Access Compliance Report

Public Rights-of-Way

(Curb Ramps)

Intersection ID: 19525	Main Street: COLONY_RD	Cross Street: ROXBOROUGH_RD	Location: NE
ADA ID: 2115CFF58FBA	Ramp Type: PerpDiag	Initial Pass/Fail: Fail	Overall Compliance: No
Severity Score: 13.75			
Codes/Mitigation Info/Possible Solution		Field Measurements/Component Compliance

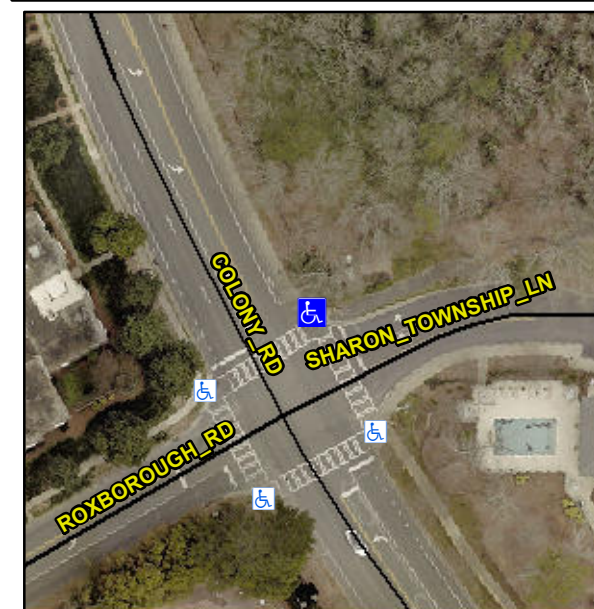
Not Found, R304.2.2, R304.5.3

Compliance	Description	Data	Compliance	Description	Data
N/A	Ramp Length (in)	61.5	No	Ramp Slope (%)	9.4
Yes	Ramp Width (in)	48.0	No	Ramp XSlope (%)	4.6
N/A	Flare Type LT	N/A	N/A	Flare Type RT	N/A
N/A	Flare Slope LT (%)	N/A	N/A	Flare Slope RT (%)	N/A
N/A	Flare Traversable LT?	N/A	N/A	Flare Traversable RT?	N/A
N/A	Landing Length (in)	N/A	N/A	DWS Provided?	N/A
N/A	Landing Width (in)	N/A	N/A	DWS Contrast?	N/A
N/A	Landing Slope (%)	N/A	N/A	DWS Length (in)	N/A
N/A	Landing X Slope (%)	N/A	N/A	DWS Full Width?	N/A
N/A	Landing Curb? (Y/N)	N/A	N/A	DWS Offset (in)	N/A
N/A	Shared Landing?	N/A			
N/A	Gutter Ponding?	N/A	N/A	Gutter Slope (%)	N/A
N/A	Gutter Lip Ht (in)	N/A	N/A	Gutter X Slope (%)	N/A
N/A	Painted X Walk1?	Yes	N/A	Painted X Walk2?	Yes
	X Walk 1 Direction	To SW		X Walk 2 Direction	To SE
N/A	X Walk 1 Width (in)	113.0	N/A	X Walk 2 Width (in)	88.0
	X Walk 1 Slope (%)	1.2		X Walk 2 Slope (%)	1.2
	X Walk 1 X Slope (%)	4.5		X Walk 2 X Slope (%)	0.3

Remove & Replace Curb Ramp With Two New Directional Ramps or Equivalent.
